From: Troy E [REDACTED]
Sent: Monday, April 22, 2024 4:40 PM
To: John Jay
Subject: Canopy Project

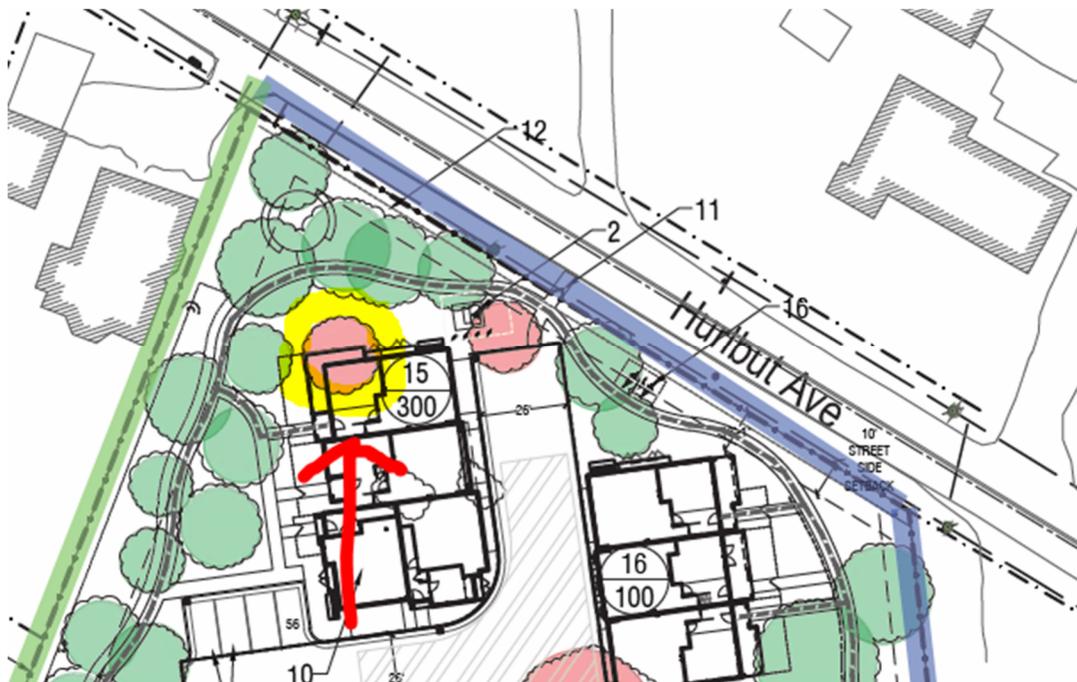
I live on 970 Hurlbut Ave and my property adjoins the proposed development in the northeast corner. In the northeastern portion of the project there is an existing redwood tree approximately 40' tall that is proposed for removal per the site plan prepared by City Ventures (snippet below). The tree that is proposed for removal is a mitigation tree and was installed as part of the O'rielly project. The tree's installation location is intentional, and is there to screen and reduce any visible impact that the Orielly project or any other project could have on my residence. This tree (along with most trees planted to reduce visual impacts) can't be removed and is part of the approval process and mitigation of the Orielly property. The snippet below shows the tree of concern. The remaining trees that are mitigation trees that are proposed for removal shouldn't be torn out either but they are of less of a concern and do not screen the impacts of this development from my home. The design proposed by Venture City will need to be slightly modified accordingly. This topic was brought up during the City Council meeting and needs to be addressed.
